Milwaukee Historic Preservation Commission November 7, 2022

Resolution relating to a Certificate of Appropriateness for window replacement on the lower levels at 1015 N. 9th Street, St. Benedict the Moor Roman Catholic Church, an individually designated historic property, for the Province of St. Joseph of the Capuchin Order..

Resolution relating to a Certificate of Appropriateness for the construction of a new house at 2409 N. Terrace Avenue, in the North Point North Historic District, for Terrace 2409 LLC.

1 EXISTING EAST WINDOWS

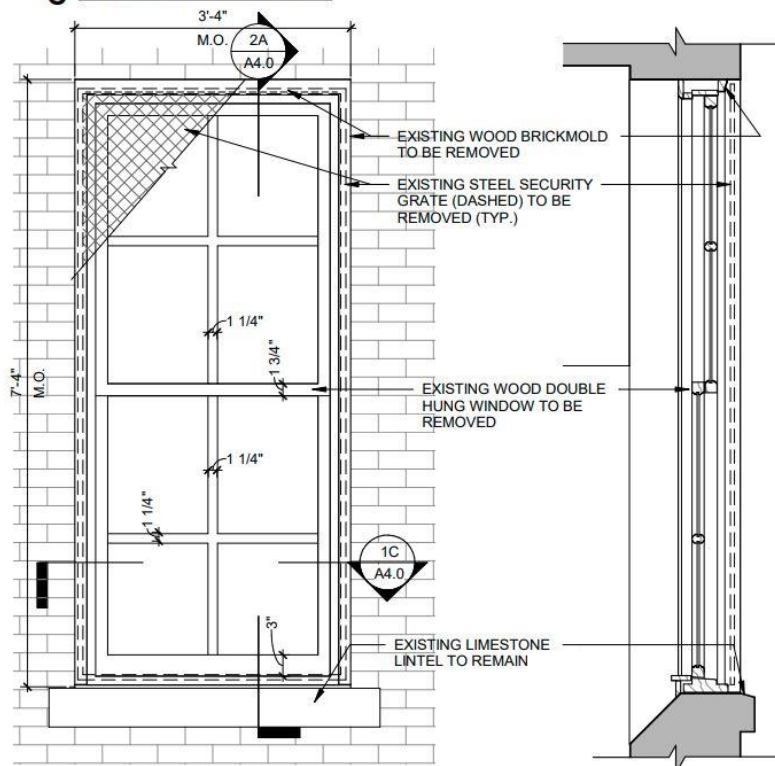
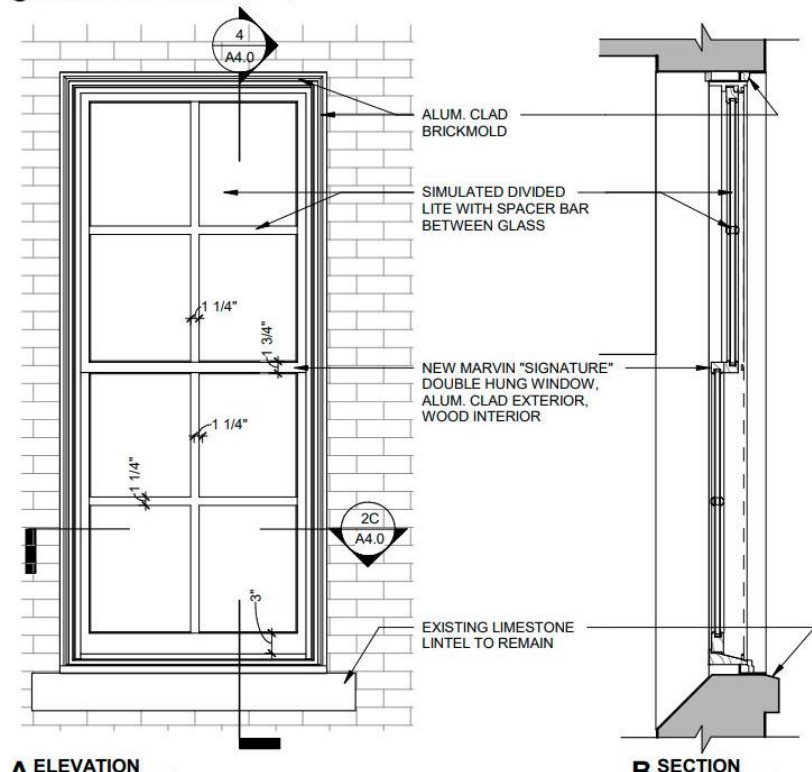
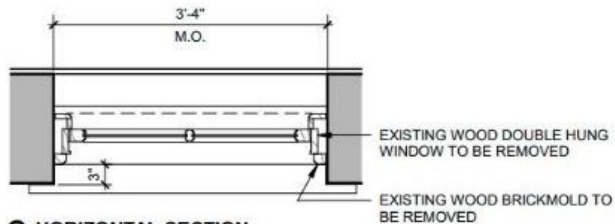
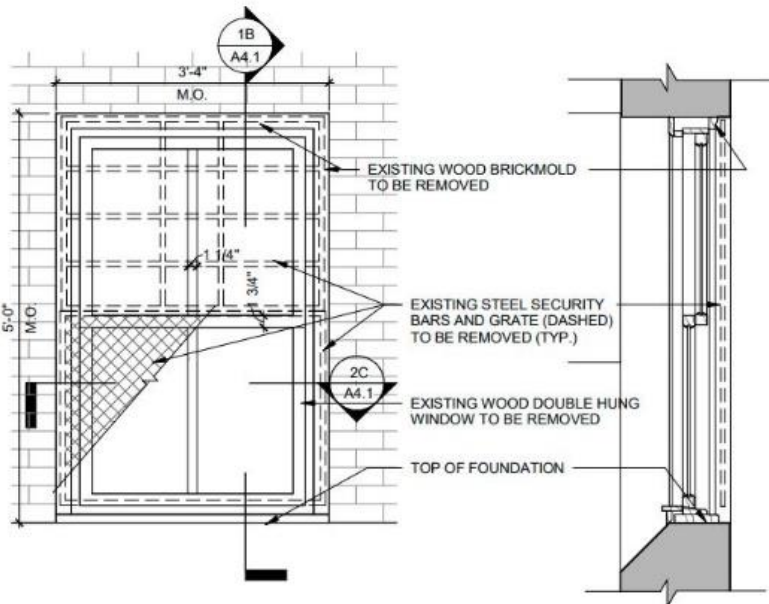
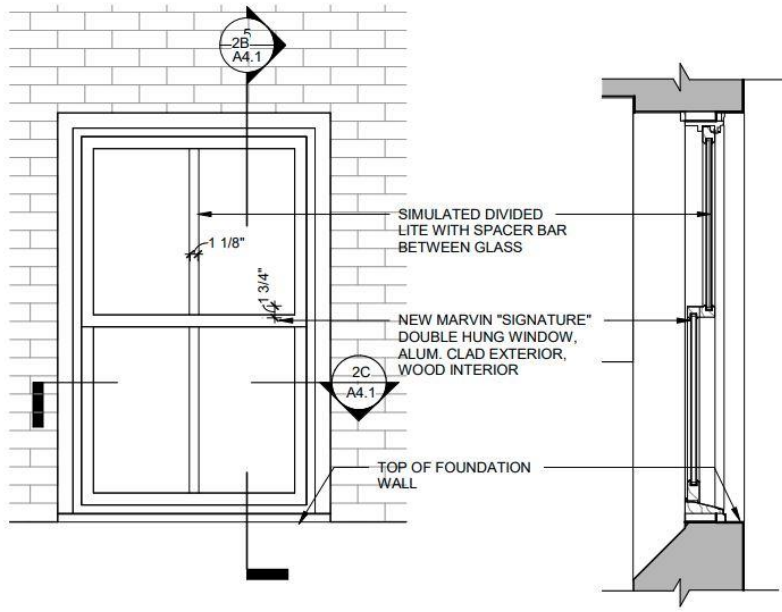
Although the architects have indicated the new windows will be all wood, the church wants to install aluminum clad windows for ease of maintenance.

SITING AND FORM AND SCALE

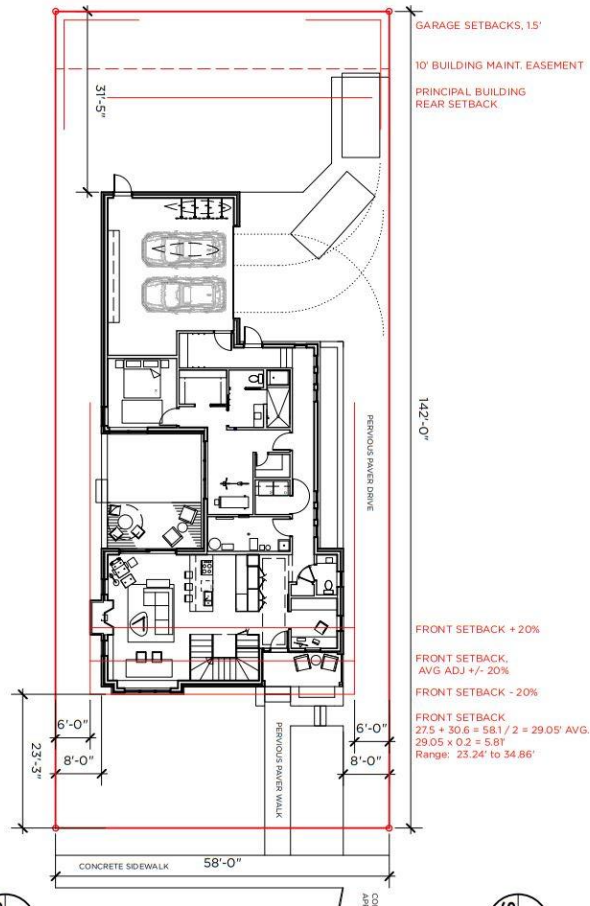
FRONT SETBACK
 $27.5 + 30.6 = 58.1 / 2 = 29.05'$ AVG.
 $29.05 \times 0.2 = 5.81'$
 Range: 23.24' to 34.86'

Applicant will utilize a
24 foot setback.
